EUROCOPTER
DIRECTION TECHNIQUE SUPPORT
13725 MARGNANE CEDEX FRANCE

EMERGENCY **ALERT SERVICE BULLETIN**

COLIBRI	Number	VERSIONS	
EC120	24A012	Civil:	B

EMERgency SWitch (EMER SW) wiring

Figure 1 - "EMER SW" Switch

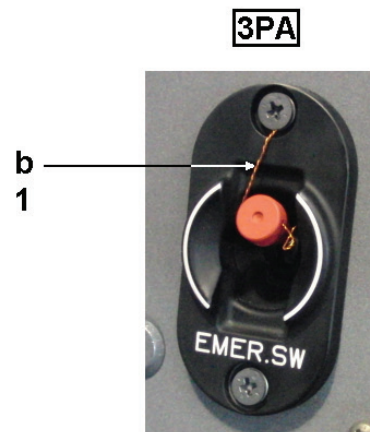
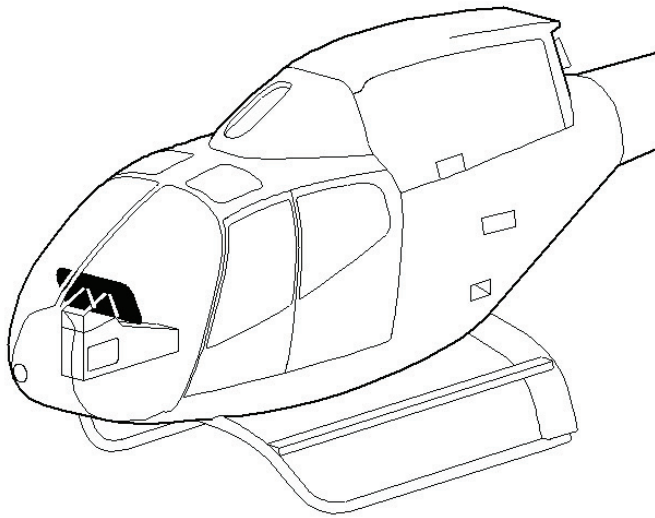
2.B.2. Wiring modification (Figures 1 and 2)

- Using tool (zz), reconnect "EMER SW" (3PA) switch wires in compliance with Figure 2:
 - . Wire marked "2431-0016" to terminal "3PA-1A".
 - . Wire marked "2431-0003" to terminal "3PA-2A".

- . [BAT/EPU]: ON
Check that all equipment items are energized.
- . [BAT/EPU]: OFF
- . [GENE]: ON
Check that all equipment items are energized.
- Stop the engine and rotors.
- Replace snapwire (b) (Figure 1) with snapwire (1).

Figure 2 - "EMER SW" Switch Wiring

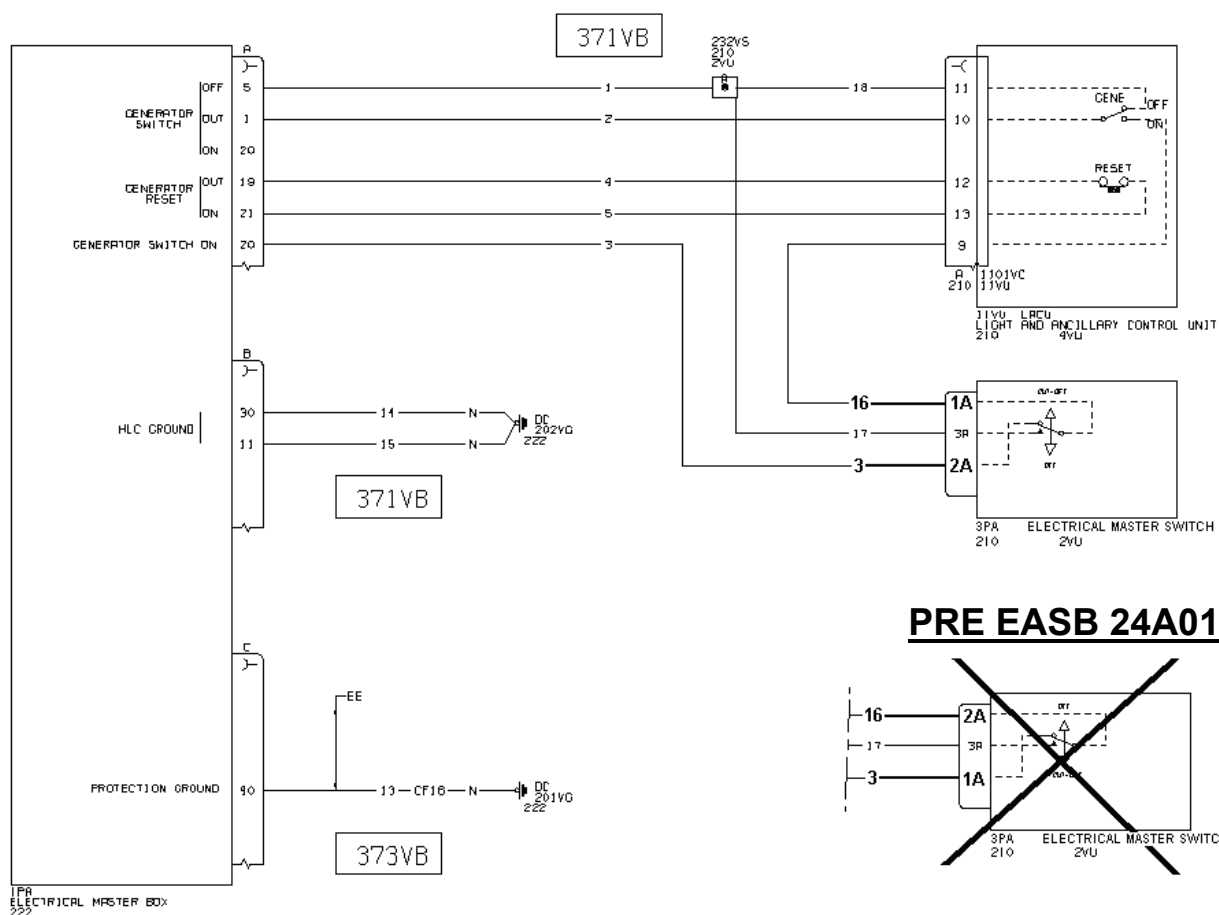
The technical investigations conducted revealed that cross-wiring at the "EMER SW" switch caused the malfunction. In this configuration, the "smoke in the cockpit/cargo" procedure described in the flight manual does not isolate the equipment electrical power supply.

Pending update of WDM 24-30-01-002, refer to the wiring diagram of Figure 2, when performing a maintenance operation on the "EMER SW" switch.

The wiring modification will be incorporated in WDM 24-30-01-002 as part of a future revision.
